# 2AM-MEL1631 Water Licence Amendment

## *Information Request Responses*

Submitted to:  
**Nunavut Water Board**

Submitted by:  
**Agnico Eagle Mines Limited – Meliadine Division**

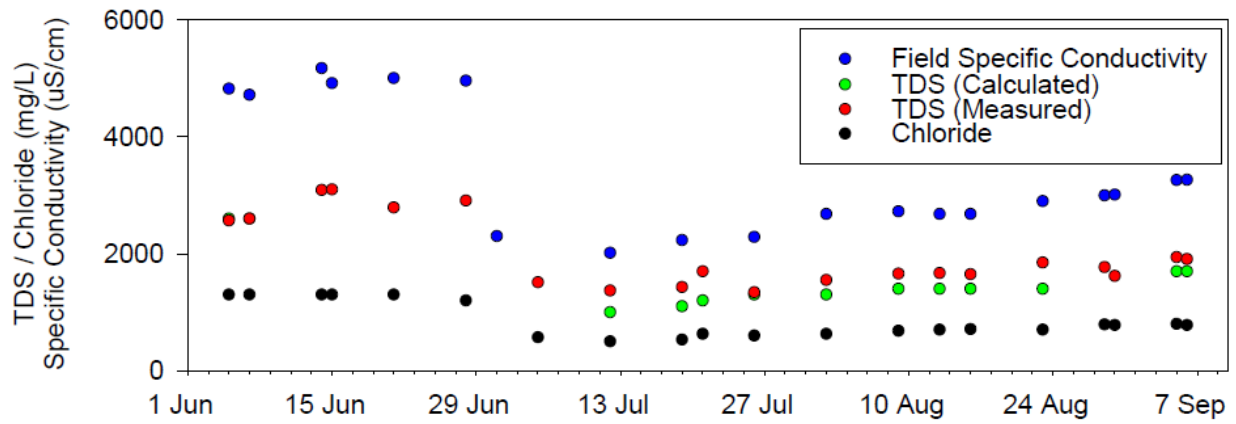
*ECCC requests that the Proponent clarify the need for a discharge limit for TDS of 3500 mg/L, given the predicted concentrations.*

As detailed in the response to CIRNAC-2, the maximum average concentration discharge threshold for TDS of 3,500 mg/L was determined to be protective for the receiving environment of Meliadine Lake based on three criteria outlined in the WQ-MOP Rev3:

- 1) The effluent was shown to not be acutely toxic at concentrations up to 3,500 mg/L
- 2) The discharge was shown to be rapidly assimilated in the Meliadine Lake receiving environment
- 3) Concentrations at the edge of the mixing zone were less than TDS concentrations shown to cause adverse effects during chronic toxicity tests

**Figure 3-1** Relationship between chloride and calculated TDS, and chloride and measured TDS, in discharge from CP1 (End of Pipe) and in Meliadine Lake (Receiving Environment) during the 2020 discharge period.

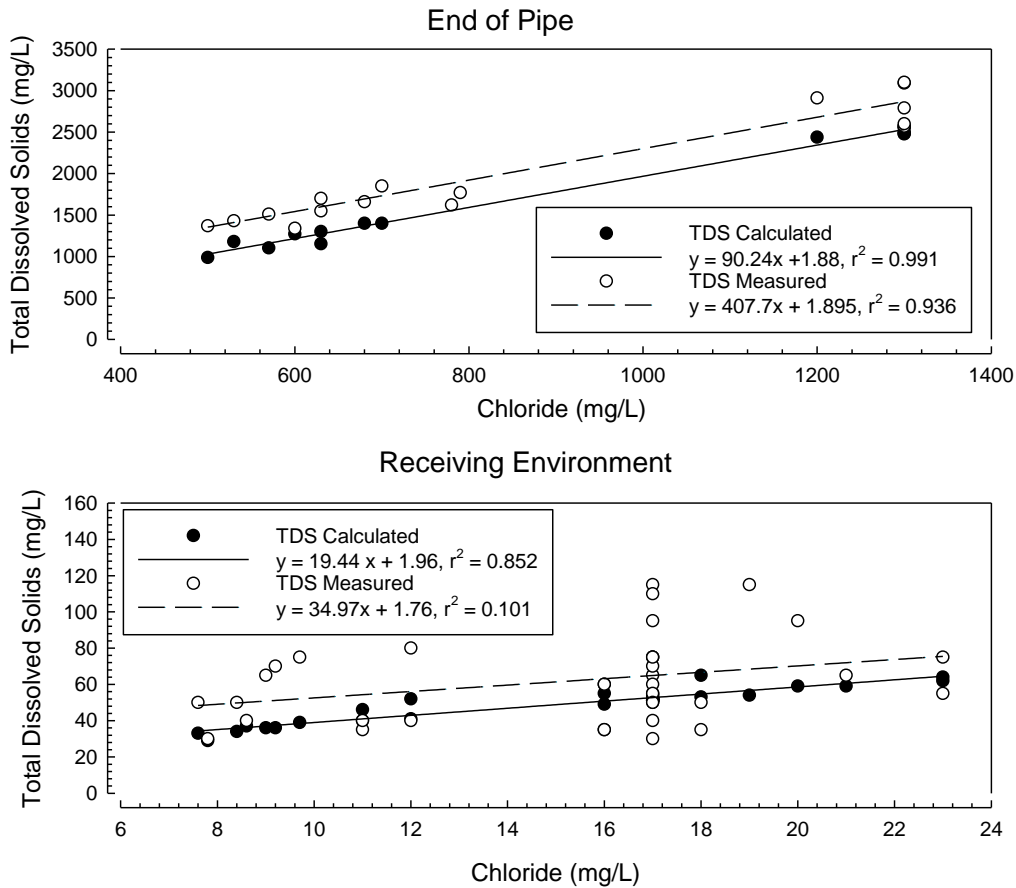
*Please clarify whether Agnico Eagle will be relying on measured TDS, calculated TDS, or a combination of the two when evaluating compliance with the discharge criteria and determining when to implement adaptive management strategies. Please include a comparison between the accuracy of calculated vs measured values.*

Figure 3-1 show summary data that supports Agnico Eagle’s position. The box and whisker plot shows a more consistent relationship between chloride with calculated TDS concentrations compared to

measured TDS concentrations in discharge from CP1 and Meliadine Lake (i.e., the edge of mixing zone, mid-field, and reference locations; the receiving environment) from data collected during the Emergency Amendment to Meliadine Lake (June to August 2020).

Using calculated TDS concentrations means that changes in the amount of TDS in waters associated with Meliadine Mine will be detected with more certainty than if measured TDS concentrations are used. Therefore, the use of calculated TDS concentrations is expected to provide more consistent and reliable results when tracking temporal and spatial trends and assessing conformity to thresholds.

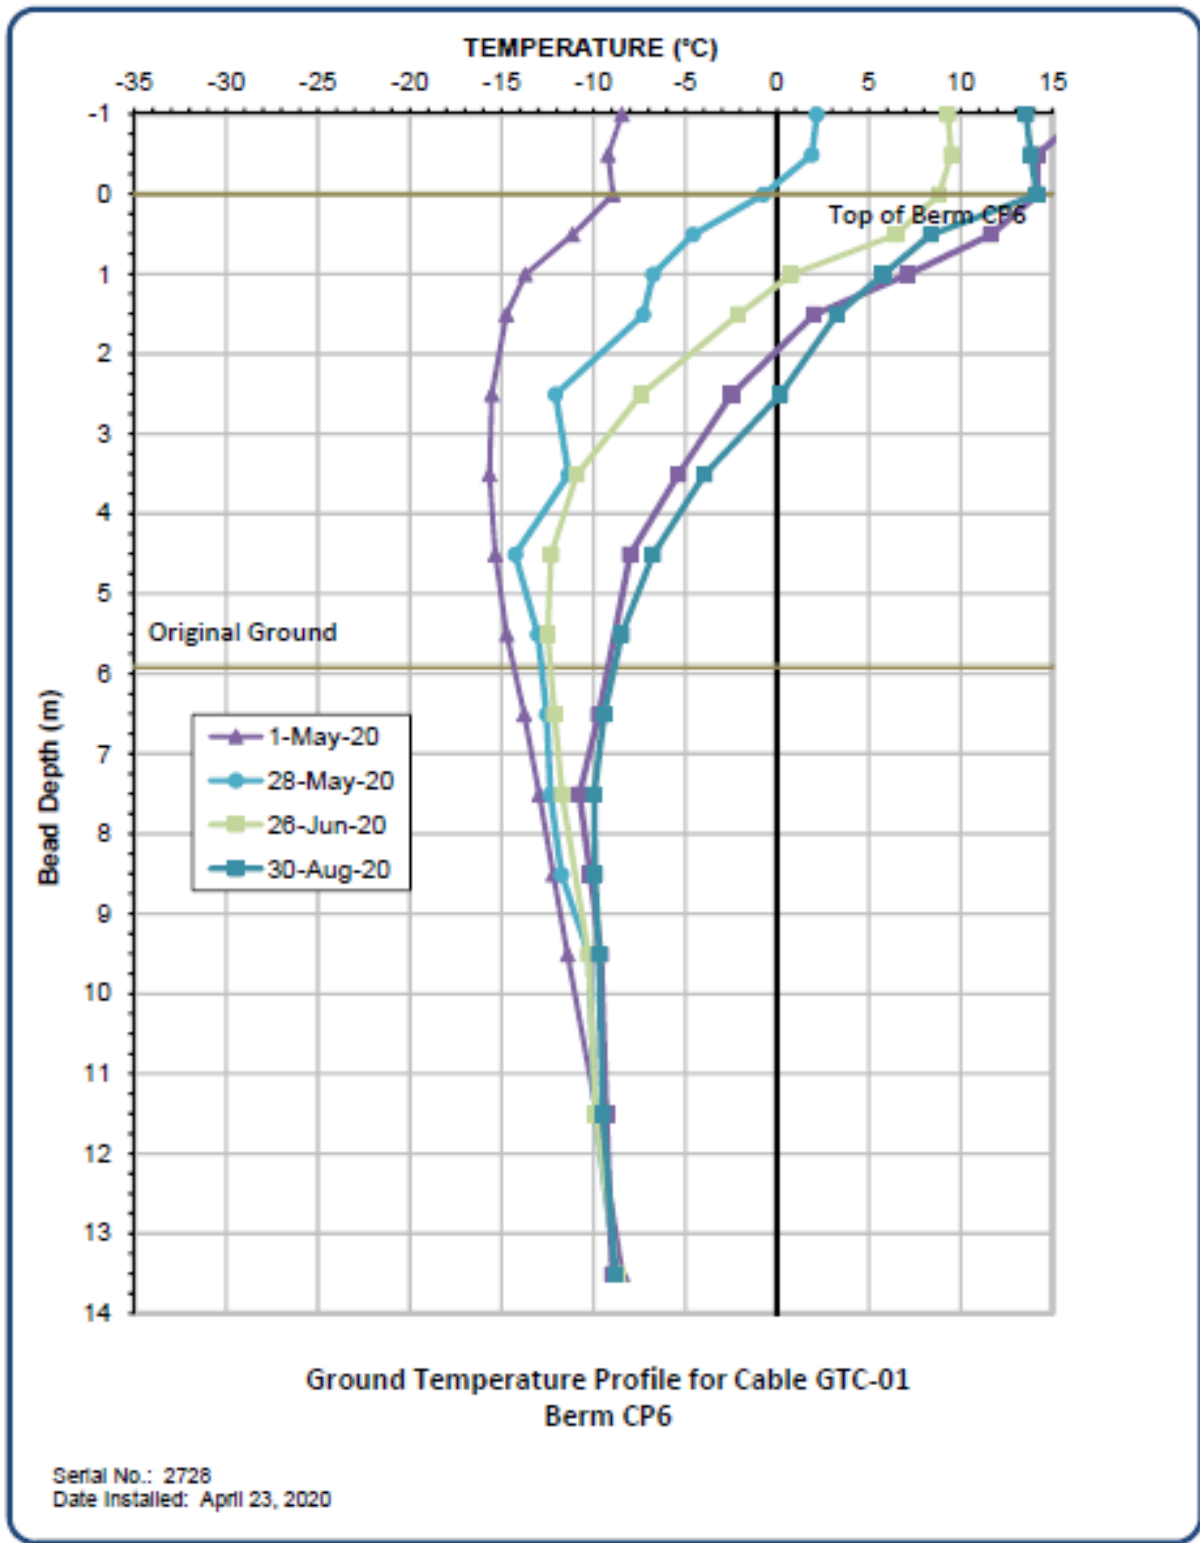
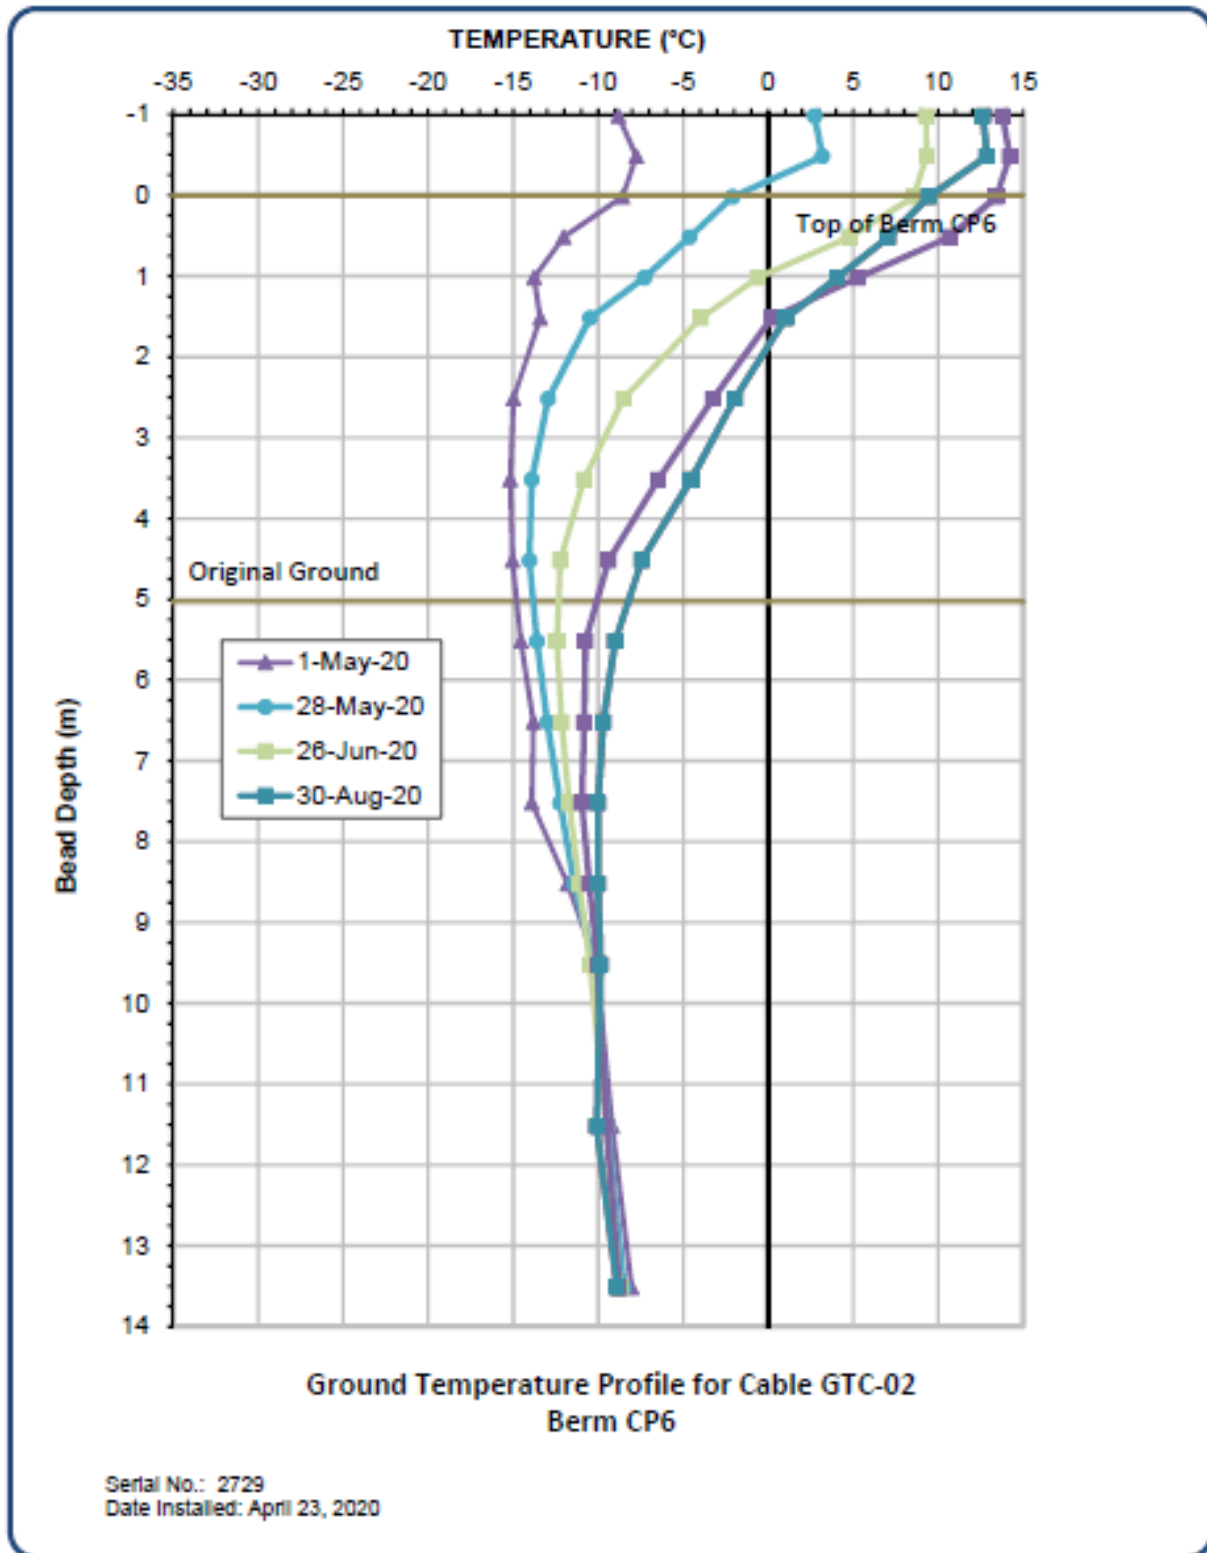
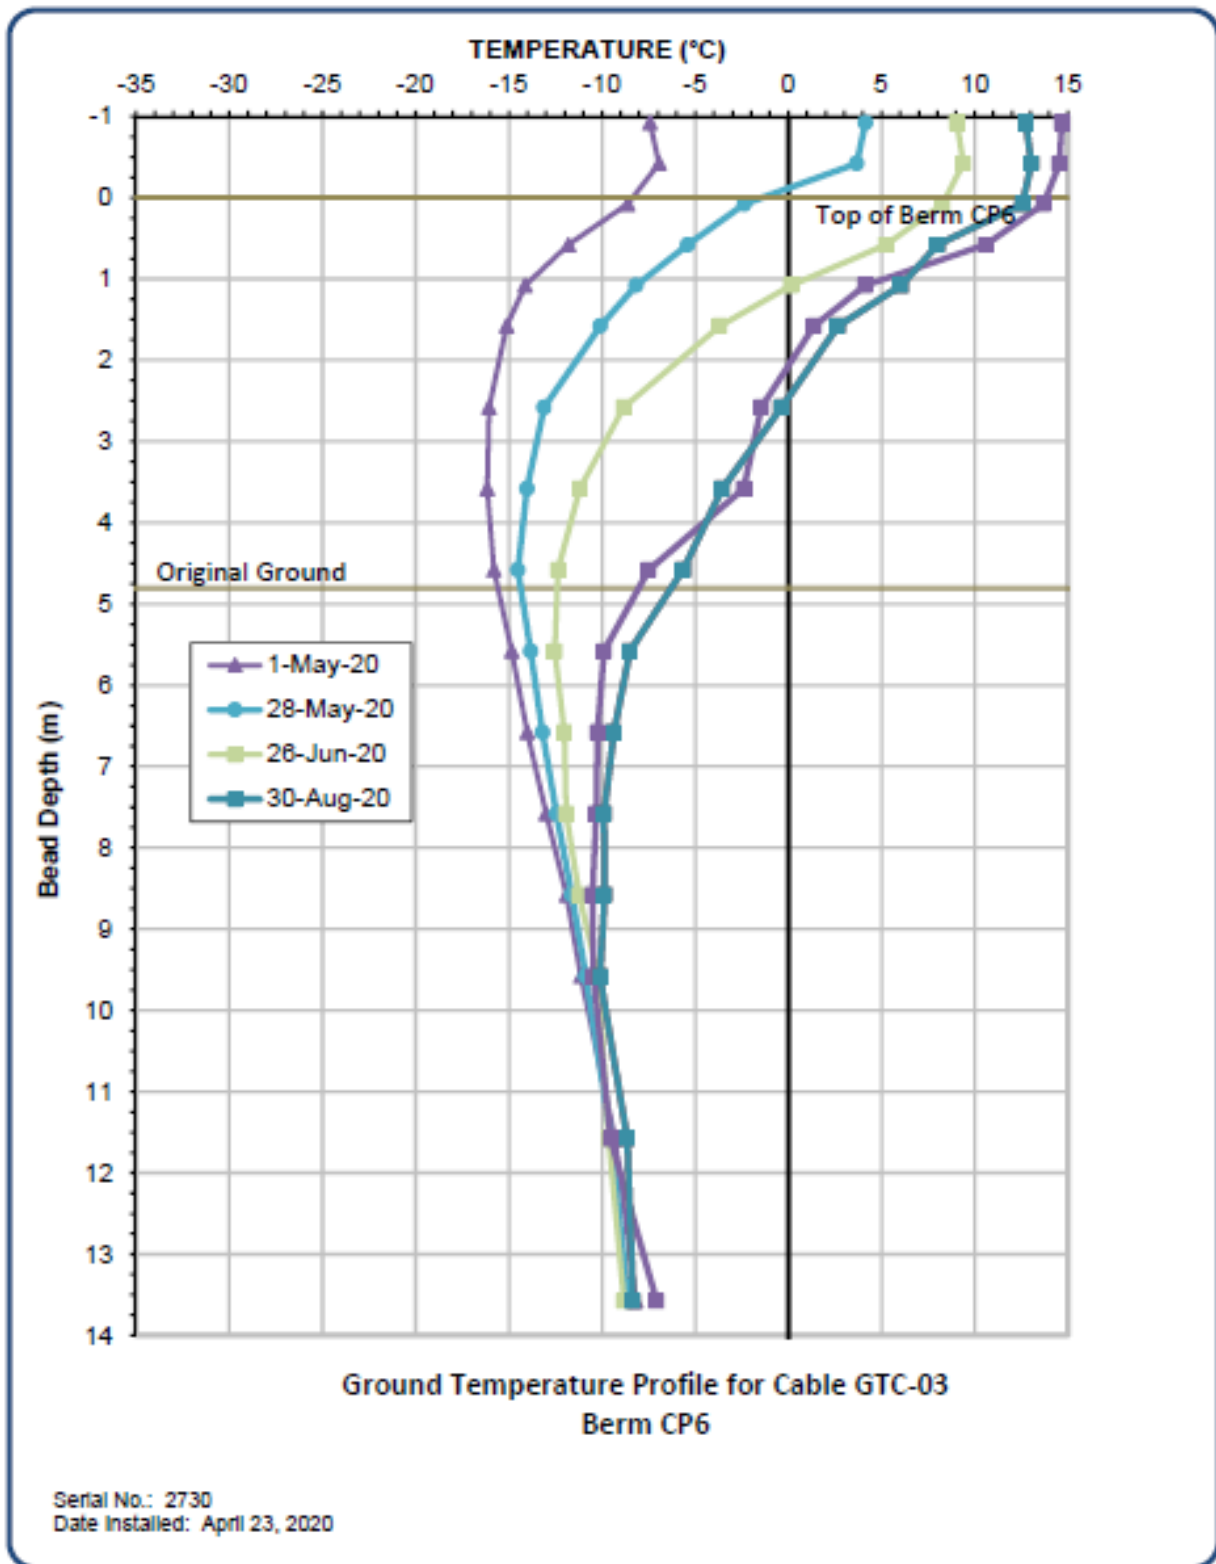
*The KIA requests that the proponent provide the current thermal data available for the area downslope of WRSF 3, Berm CP-2 and Berm CP-6 to the edge of Meliadine Lake.*

The figures below present the thermistor data located in the downstream slope of Berm CP-6. It should be note the thermistors haven't been in place for a full year, however to date the berm appears to be fulfilling its function and the underlying ground has remained frozen.
